EAST COUNTY SUBSTATION PROJECT MINOR PROJECT REFINEMENT REQUEST FORM

Date Submitted:	03-22-13 (Original Submittal) 05-13-13 (Resubmittal)	Request #:	2	
Date Approval Required:	05-17-13	Landowner:	[This information has been redacted due to its confidential nature]	
APNs:	Domingo Lake Construction Yard: [This information has been redacted due to its confidential nature] Jewel Valley Construction Yard: [This information has been redacted due to its confidential nature]			
Refinement from (check all that apply):				
<input type="checkbox"/> Mitigation Measure	<input type="checkbox"/> APM	<input checked="" type="checkbox"/> Project Description	<input type="checkbox"/> Drawing	<input type="checkbox"/> Other
Identify source (mitigation measure, project description, etc.):				
<p>Figures B-7 through B-9A in the Project Description of the Final Environmental Impact Report/Environmental Impact Statement (EIR/EIS) for the East County Substation Project (Project) depict the originally proposed locations of two fly yards between the Southwest Powerlink and rebuilt Boulevard Substation, which are now referred to as the Domingo Lake and Jewel Valley construction yards. Page B-24 of the Final EIR

Figure 1: Domingo Lake Construction Yard Refinement

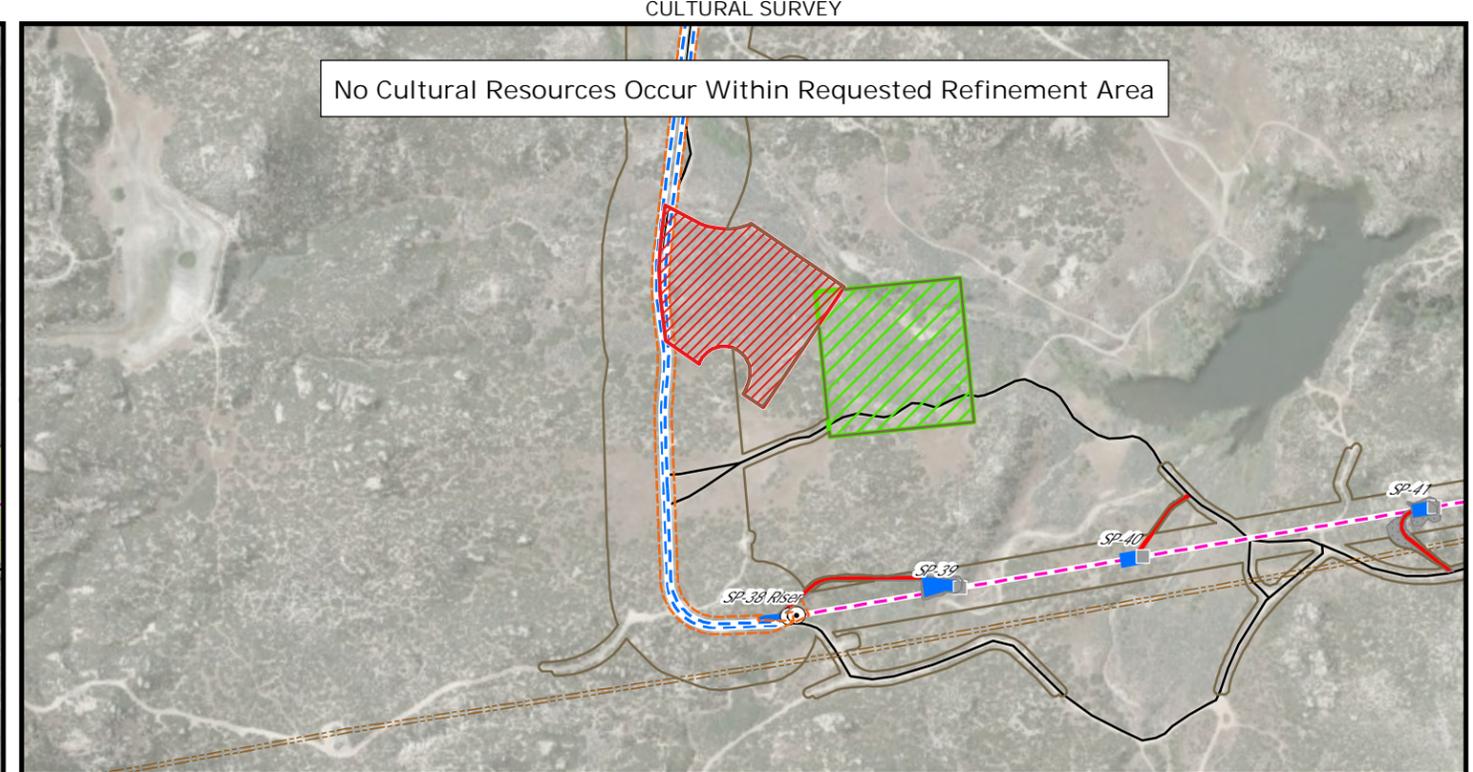
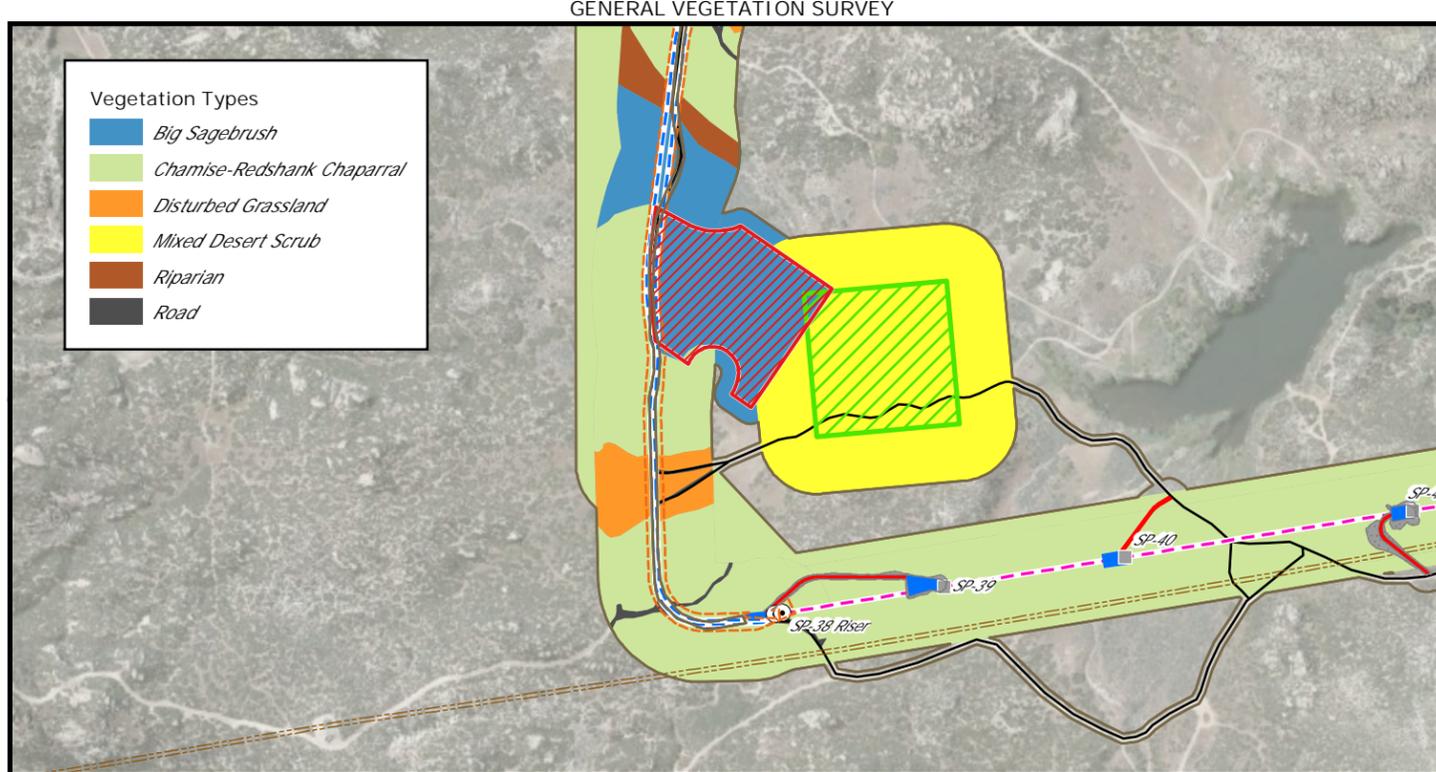
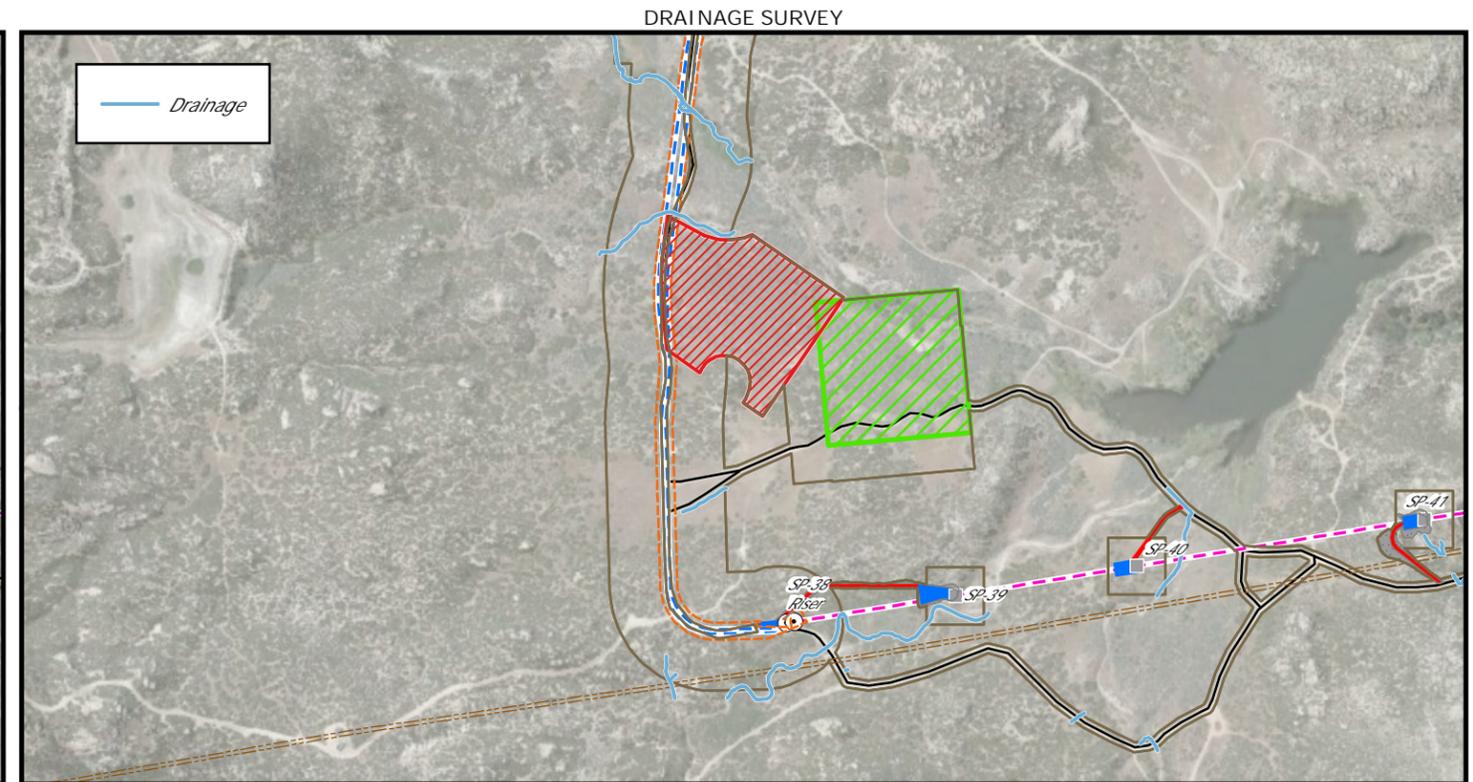
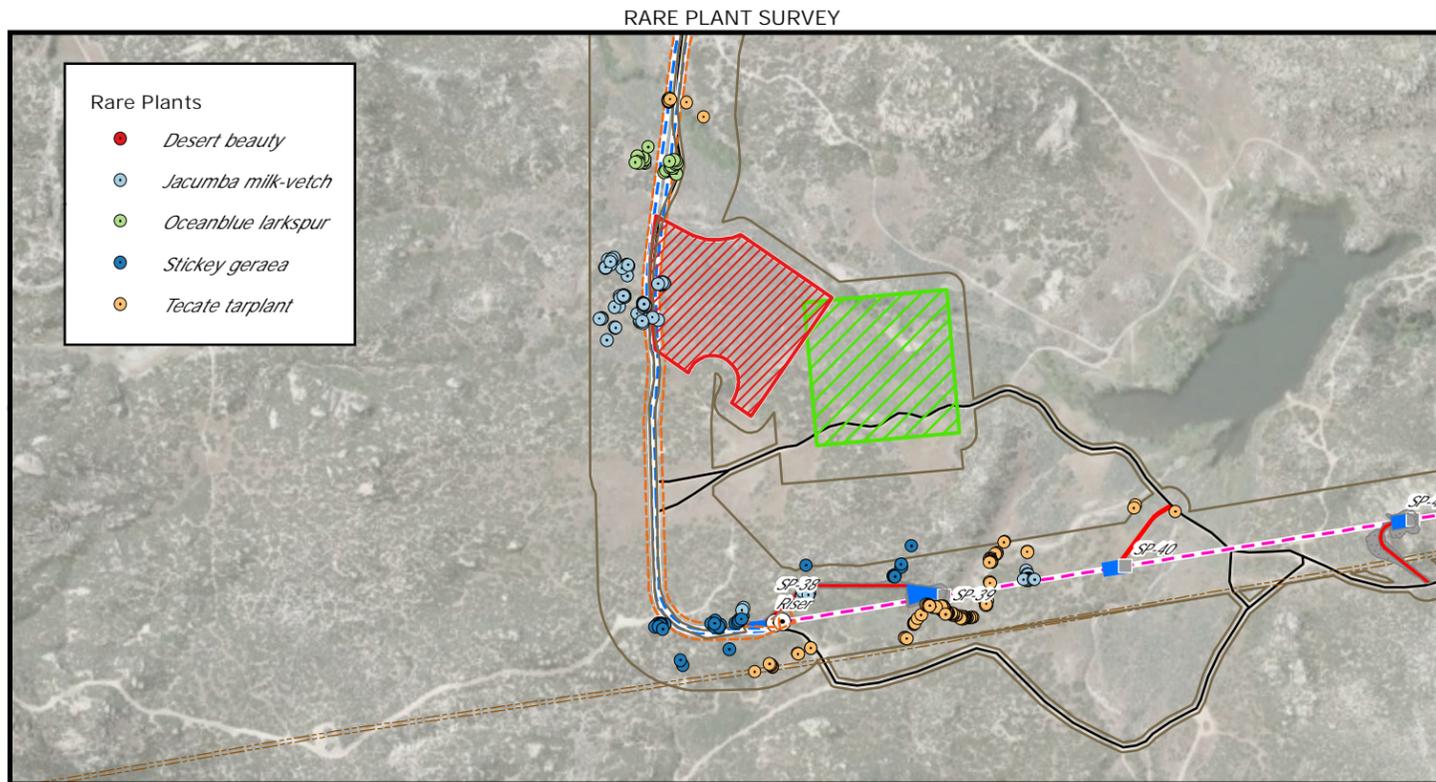
- Shift of approximately 550 feet to the northwest

Provide need for refinement (attach drawings and photos as needed):					
<p>The approximately 550-foot shift that is being requested for the Domingo Lake Construction Yard is needed based on the topography of the area, as well as the proximity of the new location to the underground portion of the 138 kV transmission line between steel pole 38 and the Boulevard Substation rebuild site. This footprint shift will allow the construction crew to access the yard from the underground alignment workspace, rather than require that the materials be transported over 500 feet to and from the approved yard via a separate access road. Figure 1: Domingo Lake Construction Yard Refinement in Attachment C: Site Maps depicts the approved Domingo Lake Construction Yard, as well as the requested refinement.</p> <p>The addition of the requested temporary access road north of the approved Jewel Valley Construction Yard is needed to physically utilize the yard. This temporary access road was unintentionally omitted from the original Project documents. The temporary distribution tap is needed to provide power to the construction yard for operation of trailers and construction equipment. Grading of the intersection of Jewel Valley Road and the existing unpaved road located north of the Jewel Valley Construction Yard is needed to allow safe entrance to the unpaved road for construction vehicles and equipment traveling to the construction yard from Jewel Valley Road. Figure 2: Jewel Valley Construction Yard Refinement in Attachment C: Site Maps depicts the approved Jewel Valley Construction Yard, the requested temporary access road, the temporary distribution tap, and the area of the existing unpaved road to be graded.</p>

Figure 2: Jewel Valley Construction Yard Refinement

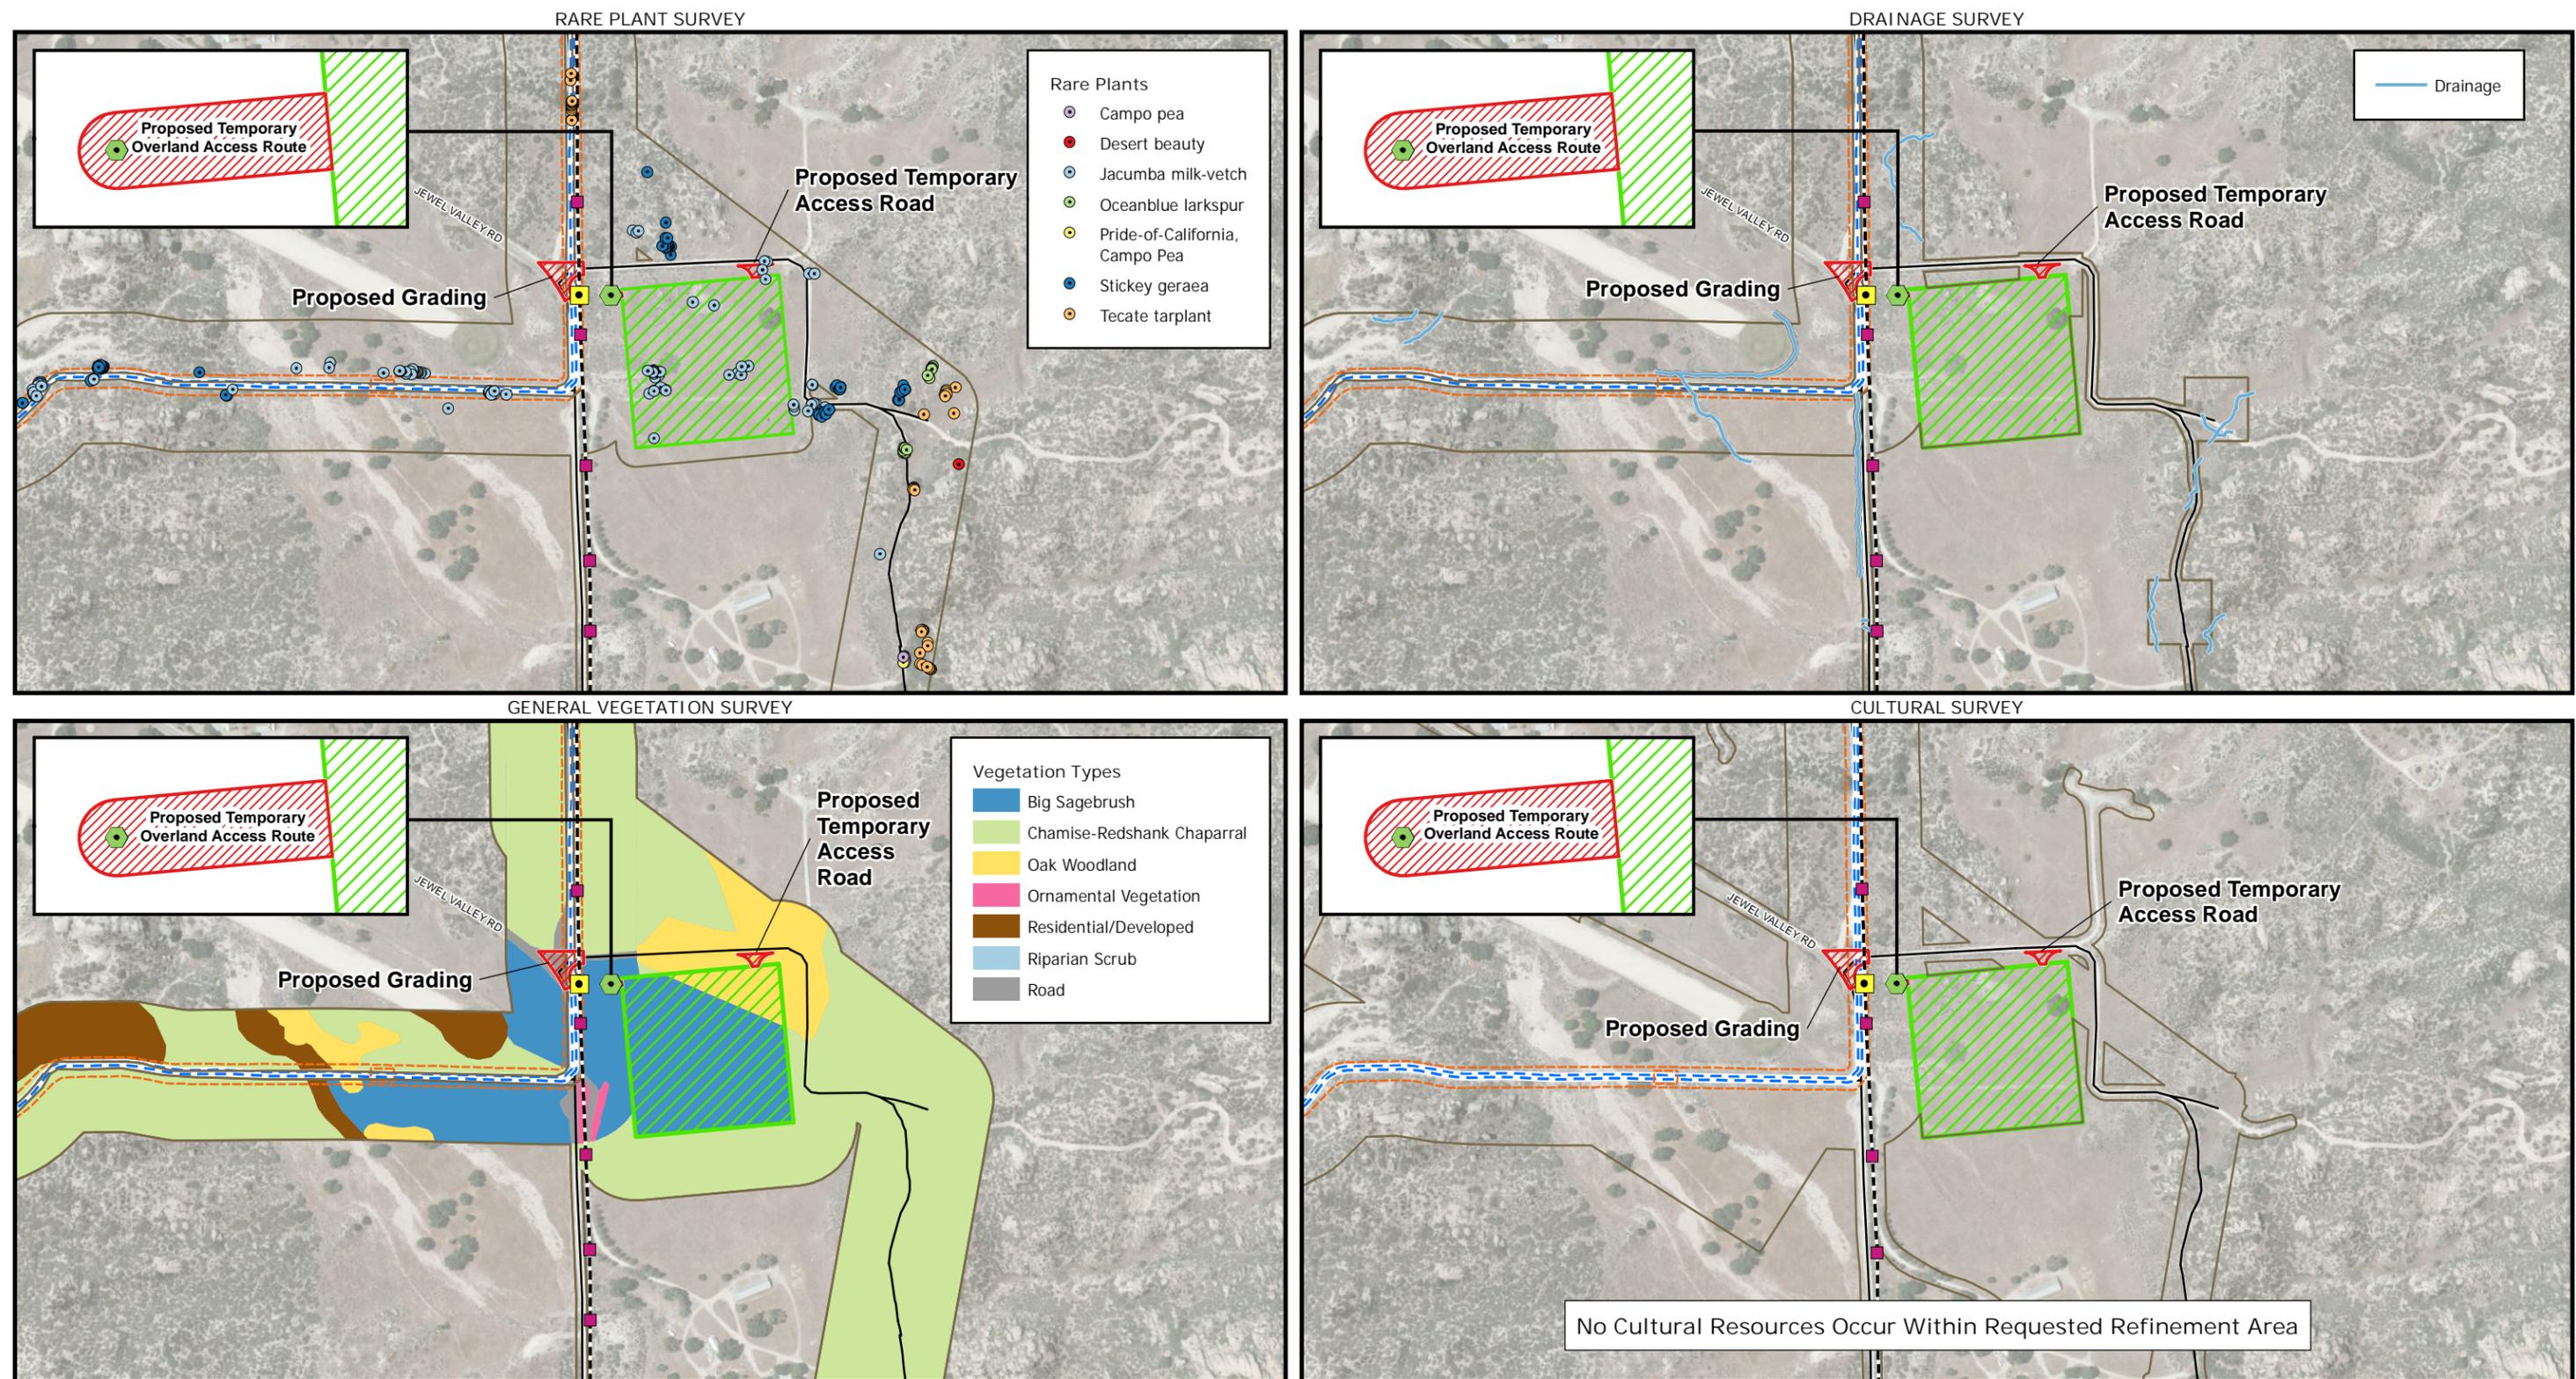
- Addition of a new temporary access road
- Addition of a temporary 12 kV distribution service line extension (distribution tap)
- Additional grading activities at the intersection of Jewel Valley Road and the existing access road located north of the Jewel Valley Construction Yard

The proposed refinements requested for the Jewel Valley Construction Yard are described in further detail in this paragraph. These refinements include the addition of an approximately 40-foot-long and 40-foot-wide temporary access road, an approximately 130-foot-long temporary distribution tap, and the grading of approximately 0.2-acre area located at the intersection of Jewel Valley Road and an existing unpaved road located north of the Jewel Valley Construction Yard. The new temporary access road will provide access to the yard from an existing road located north of the approved Jewel Valley Construction Yard site. The new temporary access road will require vegetation clearing and minor grading and will be restored upon demobilization. In addition, a temporary 12 kV distribution tap will be constructed to provide power to the Jewel Valley Construction Yard. The distribution tap will require the installation of one new steel pole with a transformer, which will be installed in line within an existing distribution circuit located along Jewel Valley Road. This new steel pole will be located approximately 130 feet to the west of the approved Jewel Valley Construction Yard site. In addition, a temporary steel pole will be installed approximately 30 feet to the west of the Jewel Valley Construction Yard, just outside of the existing fence line. A 12 kV distribution conductor will be strung from the existing distribution line across the new and temporary steel poles located outside of the Jewel Valley Construction Yard, continue into the construction yard, potentially connect to additional temporary poles, and terminate at the service meter panel and the construction trailers located within the construction yard. The two proposed new and temporary steel poles outside of the fence line will each be approximately 40 to 60 feet tall and require approximately 25 square feet of temporary work area around each pole. In addition, an approximately 25-foot-long, 12-foot-wide temporary overland access route from the Jewel Valley Construction Yard will be required to install the temporary steel pole located just outside of the existing fence line. Grading of the approximately 0.2-acre area at the intersection of Jewel Valley Road and the existing unpaved road will allow safe entrance to the unpaved road for construction vehicles and equipment traveling to the construction yard from Jewel Valley Road.
